REVISED RESPONSE TO REQUEST FOR ADDITIONAL INFORMATION

APR1400 Design Certification

Docket No. 52-046

RAI No.: 540-8729
SRP Section: 08.02 - Offsite Power System
Application Section: 8.2
Date of RAI Issue: 02/21/2017

Figure 1 – Typical OPC Detection and Protection Sequence Diagram (with non-Class 1E detection features)

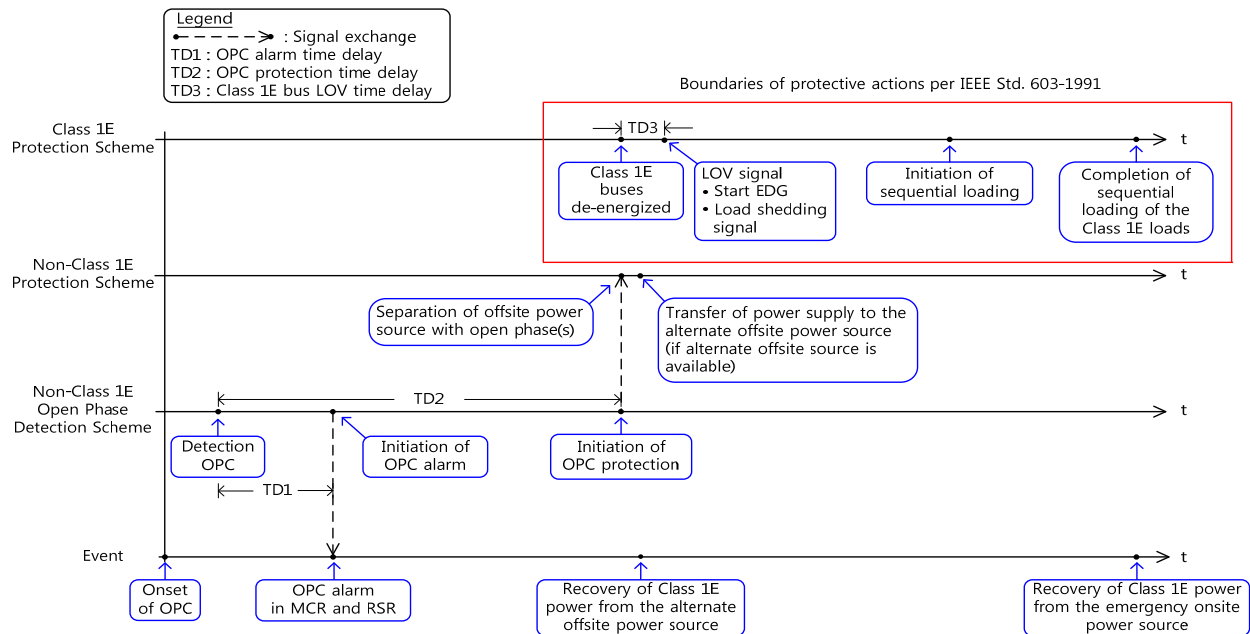
Item 1.c) Protection scheme should comply with applicable requirements including single failure criteria for ESF systems as specified in 10 CFR Part 50, Appendix A, GDC17, and 10 CFR 50.55a(h)(2) or 10 CFR 50.55a(h)(3), which require compliance with IEEE Std 279-1971 "Criteria for Protection Systems for Nuclear Power Generating Stations" or IEEE Std 603-1991, "Standard Criteria for Safety Systems for Nuclear Power Generating Stations." RG 1.153, "Criteria for Power, Instrumentation, and Control Portions of Safety Systems," provides additional guidance on this topic.

If protective features are provided in a non-Class 1E system only, a failure of the non-Class 1E scheme should not preclude the onsite electrical power system from performing its safety function given a single failure in the onsite power system.

As depicted in Figure 1, the APR1400 overall design features to address an OPC will encompass non-Class 1E and Class 1E systems. Considering the application of IEEE Std. 603-1991, only the Class 1E portion of the design features is subject to the applicable requirements, including the single failure criteria for ESF (Class 1E) systems. Compliance with the requirements for the Class 1E system is addressed in DCD Tier 2, Subsections 8.3.1.1.2 and 8.3.1.2.2. If the COL applicant chooses an OPDP system bounded only for the Class 1E system, the OPDP system as a whole should comply with applicable requirements, including single failure criteria for ESF (Class 1E) systems.

If a failure occurs in the non-Class 1E part of OPC detection and protection features (including a failure of redundant detection features), the failure does not preclude the onsite electric power system from performing its safety function given a single failure in the onsite power system based on the following.

- The worst case single failure in the non-Class 1E portion of the detection and protection features is spurious operation of the detection and protection feature. This condition causes unwanted separation of the offsite power source formerly supplying safety loads. As a result, the Class 1E buses will lose electric power unless the offsite power is transferred to the alternate offsite source. And the loss of voltage condition will automatically initiate operation of the emergency power source for safety loads and maintain the ability of supplying electric power to ESF loads.

- There is no physical or functional interface or interdependency between a failure in the non-Class 1E features and protective actions of the Class 1E features. No single point vulnerability exists between the non-Class 1E and Class 1E features owing to proper physical separation in accordance with IEEE Std. 384-1992 as endorsed by RGs 1.32 and 1.75.

- The Class 1E protection scheme is redundant and independent, so the safety function of the Class 1E system is not compromised given a single failure in the onsite power system.

- Therefore, a failure in the non-Class 1E portion of the OPC detection and protection features does not preclude the onsite electric power system from performing its safety function given a single failure in the onsite power system.
